5.0 Reactor Coolant System and ~~Connection~~Connected Systems

5.1 Summary Description

The information in this section of the reference ABWR DCD, including all subsections and figures, as modified by the STP Nuclear Operating Company Application to Amend the Design Certification rule for the U.S. Advanced Boiling Water Reactor (ABWR), "ABWR STP Aircraft Impact Assessment (AIA) Amendment Revision 3," dated September 23, 2010 is incorporated by reference with the following departures.

Figure 5.1-1 Rated Operating Conditions of the ABWR

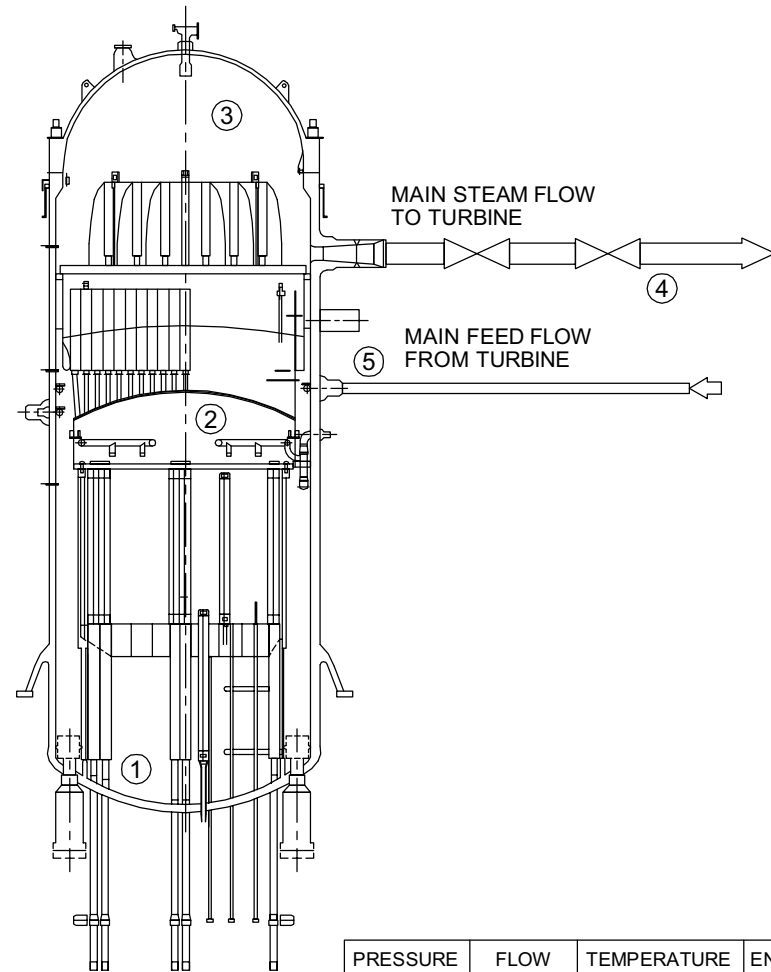
STP DEP 10.1-3 (Figure 5.1-1)
